### California Wind Energy Association

Re: Docket 23-OPT-01 - Comments on Fountain Wind Project Staff Assessment and EIR

Map 1. CalWEA Assessment of Commercially Viable Resources,\* CPUC Techno-Econ Screen Applied

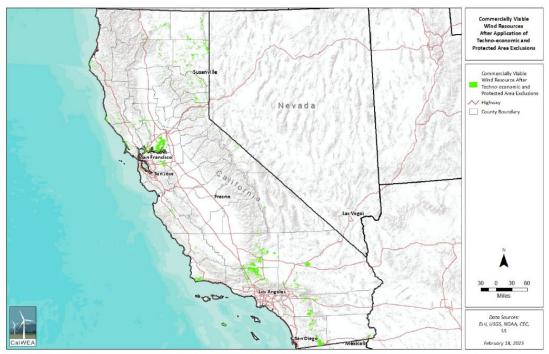
The CPUC's 2025 resource plan includes about 37 GW of battery storage and 62 GW of utility-scale solar in 2045, compared to 29 GW of all types of wind, including 9 GW of CAISO-interconnected wind. In 2023, the CAISO queue had interconnection requests for about 300 GW of battery storage and 150 GW of solar, compared to just 30 GW of wind. Relearly, there is no shortage of project sites for battery storage or solar. However, commercial-grade wind resources are extremely limited in the state, as reflected in the dearth of interconnection applications. He shortage of sites can also be seen in two maps of California wind resources prepared by CalWEA. In the appendix, Map 1 shows commercial-grade resources remaining after removing areas where wind is legally prohibited or technically infeasible. Map 2 shows the same resources after applying the Energy Commission's discretionary land-use screens for wind energy; the CPUC uses these screens to plan its resource portfolio and for transmission planning purposes. As is abundantly clear in either map, wind resources are highly constrained, underscoring the importance of approving Fountain Wind.
